Committee D-2 ON PETROLEUM PRODUCTS AND LUBRICANTS

UNAPPROVED MINUTES

T-10 OPERATIONS AND HARDWARE

TASK FORCE MEETING #3

Attachment 2

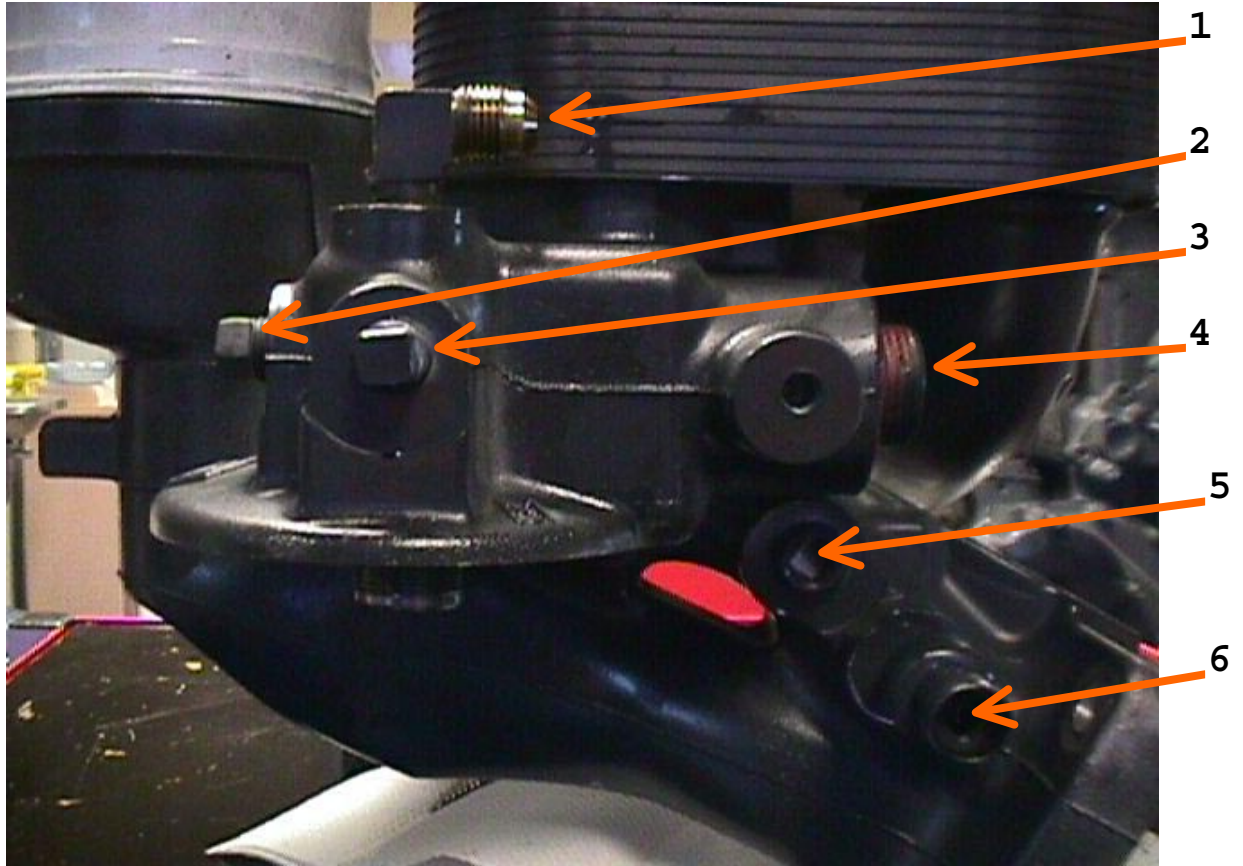
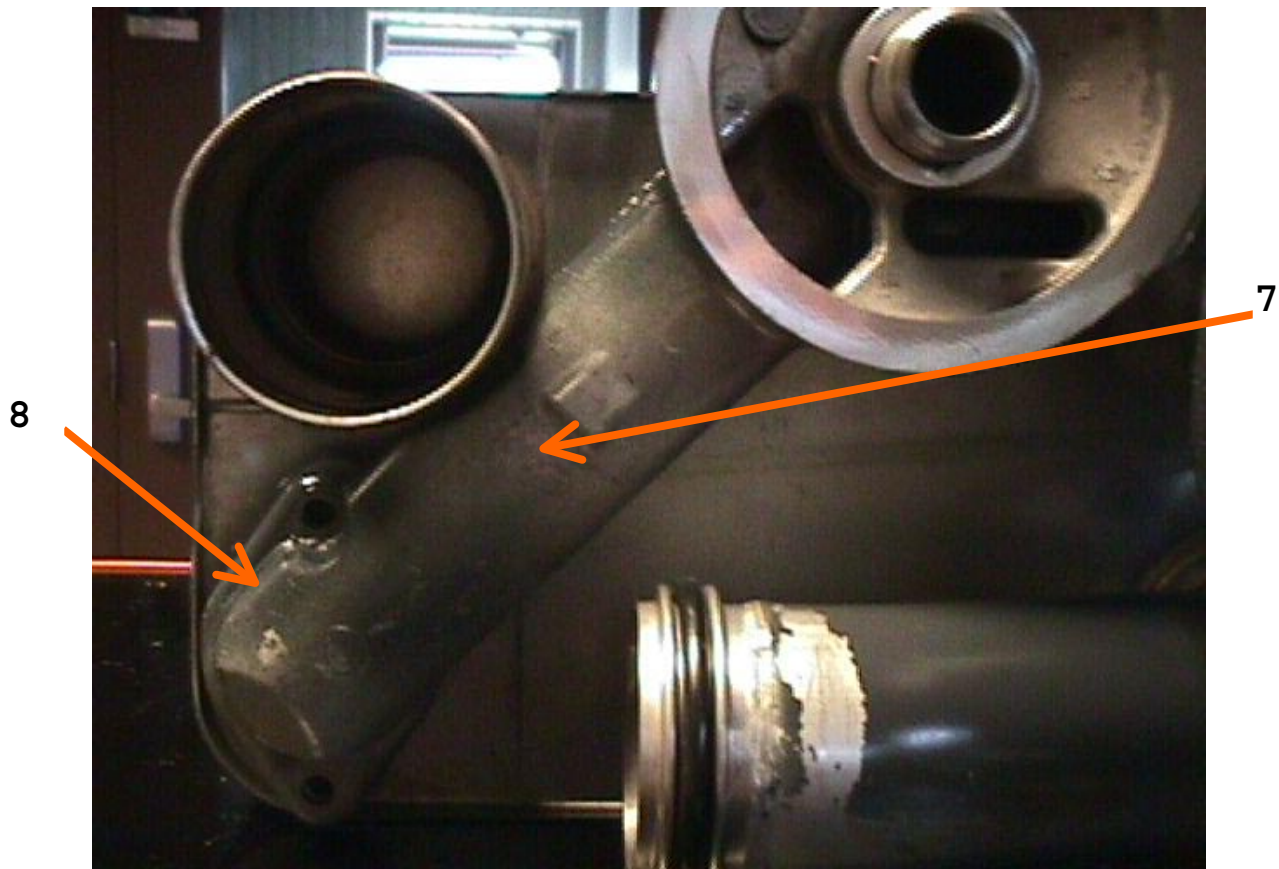
After much discussion, Riccardo Conti agreed to provide photos of the setup (included as Attachment 2) and Ken Goshorn agreed to review the setup for acceptability. POST MEETING NOTE: Ken believes this setup is acceptable, please review the setup carefully, and bring any concerns to the next meeting/conference call.
